Service Bulletin

Bulletin No.: 20-NA-020

Subject: Brake Squealing Noise

Brand:	Model:	Model Year:		Vehicle Build Date:		Engine:	Transmission:
		from	to	from	to		
Chevrolet	Silverado 2500HD/3500HD	2020	2021	SOP	March 1, 2021		
GMC	Sierra 2500HD/3500HD

5638987

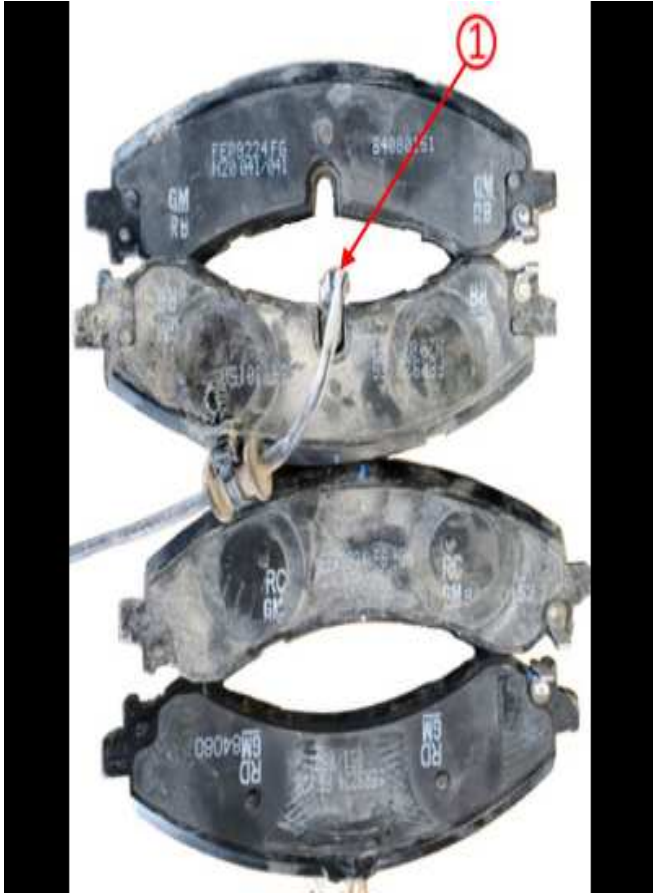
Important: Only the left side of the truck has the wear sensors (1) and is mounted on the inner pad.
Refer to *Front and Rear Disc Brake Pads Replacement* in SI.
